Access Compliance Report Public Rights-of-Way (Curb Ramps)

Main Street: COUSTEAU_LN Cross Street: COUSTEAU_LN Location: N

ADA ID: RPRK211110140716 Ramp Type: Type 1 - Perpendicular Initial Pass/Fail: Fail Overall Compliance: No Severity Score: 15

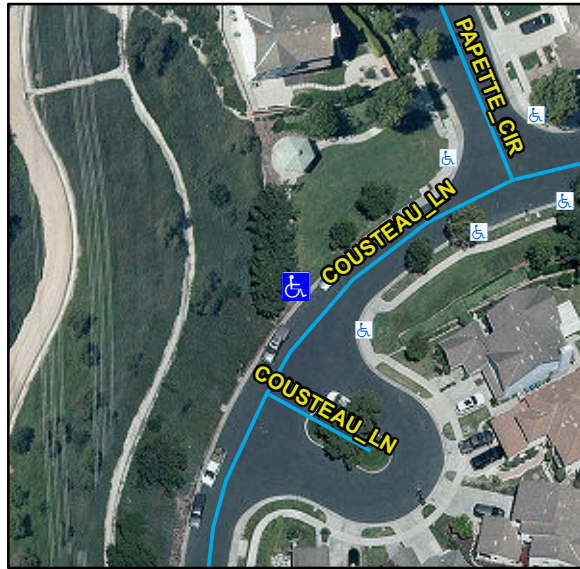
Remove & Replace Entire Ramp. Grind Gutter Lip.

R304.2.2, R302.7.2, STD 1115
